Exhibit B

Proposed Reliability Standard PRC-005-2

1. **Title:** Protection System Maintenance
2. **Number:** PRC-005-2
3. **Purpose:** To document and implement programs for the maintenance of all Protection Systems affecting the reliability of the Bulk Electric System (BES) so that these Protection Systems are kept in working order.

Figure 1: Typical Transmission System

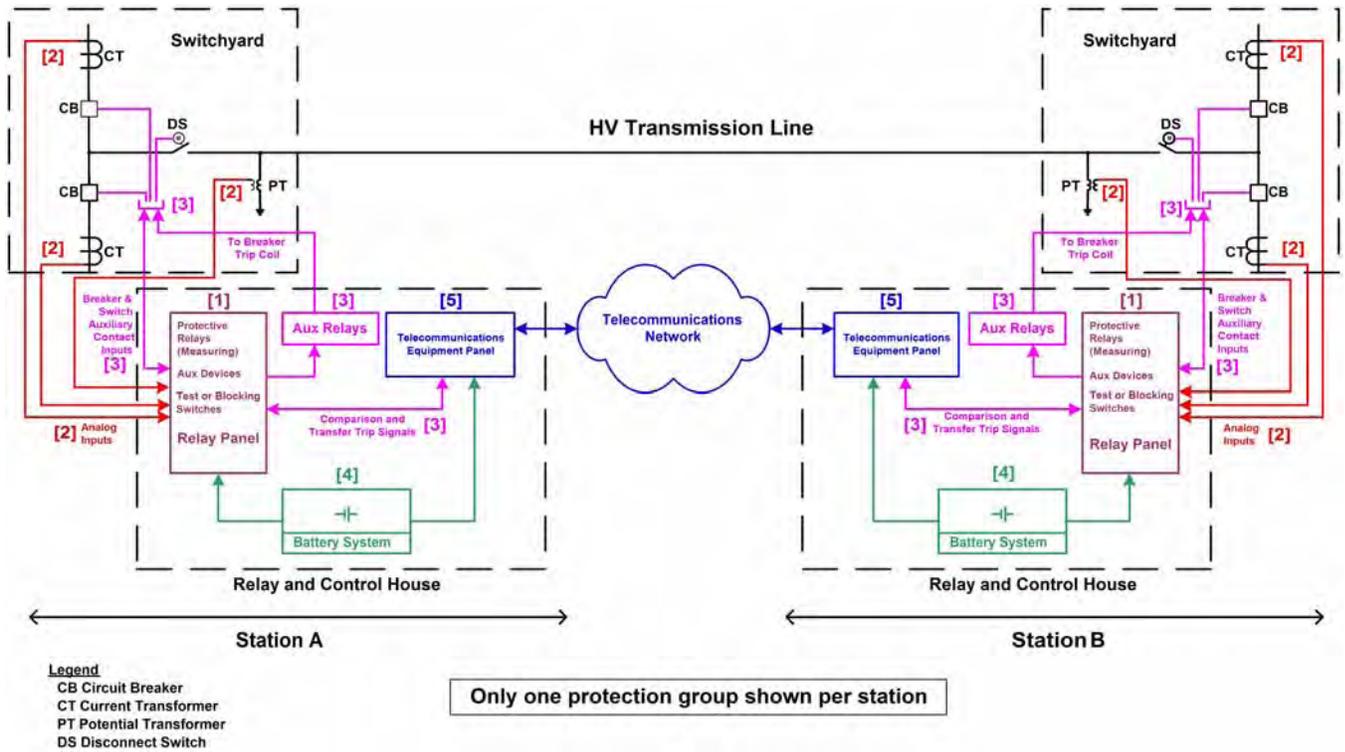
Pepco Holdings, Inc. - Affiliates	No	<p>Figure 1 & 2 Legend (page 29), Row 5, Associated Communications Systems, includes Tele-protection equipment used to convey remote tripping action to a local trip coil or blocking signal to the trip logic (if applicable). This description does not include all the various types of signals communicated for proper operation of various protective schemes (i.e., DUTT, POTT, DCB, Current Differential, Phase Comparison, synchro-phasors, etc.) A more inclusive and generic description might be - Tele-protection equipment used to convey specific information, in the form of analog or digital signals, necessary for the correct operation of protective functions. This is also consistent with the revised definition of Protection System. Conversely, excluded equipment would be - Any communications equipment that is not used to convey information necessary for the correct operation of protective functions.</p>

Figure 2: Typical Generation System

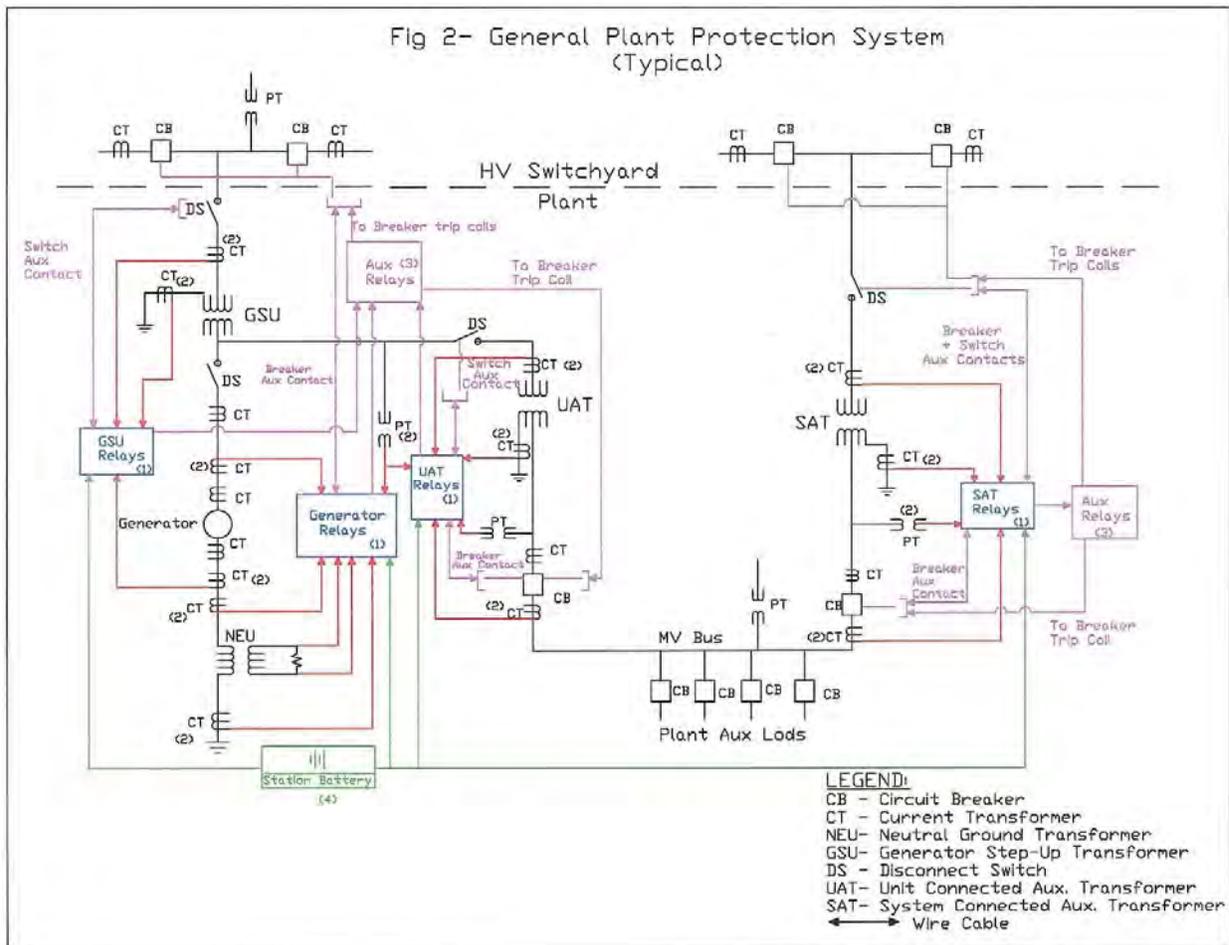
Organization	Yes or No	Question 5 Comment
Public Service Enterprise Group ("PSEG Companies")	No	<ol style="list-style-type: none"> 1. Suggest that figure 2 has a line of demarcation added that shows components specifically not part of the standard requirements. (Medium voltage bus). 2. Battery charger should be removed from table of components when a storage battery is used for the DC supply.
<p>Response: Thank you for your comments.</p> <ol style="list-style-type: none"> 1. The figures are intended to be general information and not to be inclusive of all situations. 2. The modification of the Protection System definition from “station battery” to “station dc supply” is intended to include battery chargers, and Table 1-4 within draft PRC-005-2 includes activities specifically related to battery chargers. 		
JEA	No	The Supplementary Reference document is critical in our current compliance environment to be approved as part of the standard and any standard modifications need to be kept in synchronization with the FAQ and the Supplementary Reference.

Organization	Yes or No	Question 3 Comment
Florida Municipal Power Agency	Yes	
PSEG Companies ("Public Service Enterprise Group Companies")	Yes	Figure 2 "typical generation system" shows a typical auxiliary medium voltage bus, in addition to the color coded elements suggest that a very distinct line of demarcation (dark dotted line) be added to the figure that defines the elements associated with the MV bus protection served by the station Aux Transformer and unit aux transformer are not part of the BES- PSMP PRC5 requirements. Also see comment 5 below; we suggest that the station service transformer must be connected to BES for inclusion in standard requirements. Suggest adding an explanation note to figure 2 to clarify this.
<p>Response: Thank you for your comments. Figure 2 is intended to provide an example to users, not to describe the entire applicability of the draft standard. As such, the SDT does not believe that this figure needs to reflect all possible arrangements, nor does it need to suffice to describe the entire applicability. As for your comment regarding the unit auxiliary transformer, please see the SDT response to your more detailed comments in Question 5.</p>

Organization	Yes or No	Question 3 Comment
		5. On Page 29, please improve the clarity of Figure 2. 6. On Page 31, please revise the flowchart references to R4.4.1 and R4.4.2. 7. Please correct the following formatting: Page 2, Table of Contents; Page 18, the bulleted item list; Page 23, add a space before the last paragraph.
<p>Response: Thank you for your comments.</p> <p>1. This Section of the Supplementary Reference Document has been corrected.</p> <p>2. This Section of the Supplementary Reference Document has been revised.</p> <p>3. The Supplementary Reference Document has been revised to address your comment.</p> <p>4. The Supplementary Reference Document has been revised to address your comment.</p> <p>5. The Supplementary Reference Document has been revised to address your comment.</p> <p>6. The Supplementary Reference Document has been revised to address your comment.</p> <p>7. The Supplementary Reference Document has been revised to address your comment.</p>

Organization	Yes or No	Question 3 Comment
<p>3. A higher-quality version of Figure 2 has been substituted.</p>		
<p>ITC</p>	<p>Yes</p>	<p>1. Auxiliary Relay Testing: We repeat our objection to the 6 year requirement for testing of auxiliary relays. The STD response to our previous objection was:</p> <p>Please see new Table 1-5. The SDT believes that mechanical solenoid-operated devices share performance attributes (and failure modes) with electromechanical relays and need to be tested at similar intervals. Performance-based maintenance is an option to increase the intervals if the performance of these devices supports those intervals. Auxiliary relays are, of course, electromechanical relays, but much less complicated than impedance, differential or even time-overcurrent electromechanical relays. It has been our experience that trip failures are rare and that our present 10 year control, trip tests, and other related testing are sufficient in verifying the integrity of the scheme. Section 8.3 of the Supplementary Reference notes statistical surveys were done to determine the maintenance intervals. Were auxiliary relays included in these surveys in a such a way to verify that they indeed require a 6 year maintenance interval? We recommend they be considered part of the control circuitry, with a 12 year test cycle.</p> <p>2. High Speed Ground Switch Testing: We repeat our recommendation that the standard state that a high speed ground switch is an interrupting device. We also recommend that testing requirements for High-Speed ground switches be clearly stated in the standard.</p> <p>Section 15.3 of the Supplementary Reference contains the following: It is necessary, however, to classify a device that actuates a high-speed auto-closing ground switch as an interrupting device if this ground switch is utilized in a Protection System and forces a ground fault to occur that then results in an expected Protection System operation to clear the forced ground fault. The SDT believes that this is essentially a transferred-tripping device without the use of communications equipment. If this high-speed ground switch is "...applied on, or designed to provide protection for the BES..." then this device needs to be treated as any other Protection System component. The control circuitry would have to be tested within 12 years and any electromechanically operated device will have to be tested every 6 years. If the spring-operated ground switch can be disconnected from the solenoid triggering unit then the solenoid triggering unit can easily be tested without the actual closing of the ground blade.</p> <p>We disagree that a high-speed ground switch can be adequately tested by disconnecting the solenoid triggering unit. The ability of the trip coil to "operate the circuit breaker" must be verified per Table 1-5 Row 1. The ability of the "solenoid triggering unit" to operate the ground switch should be required also. A high-speed ground switch is a unique device. Its maintenance requirements should be specifically included in the standard itself. Based on Draft 3 of the standard, this is a electromechanically operated device and would have to be tested every 6 years. A logical location would be in Table 1-5. Is there test</p>
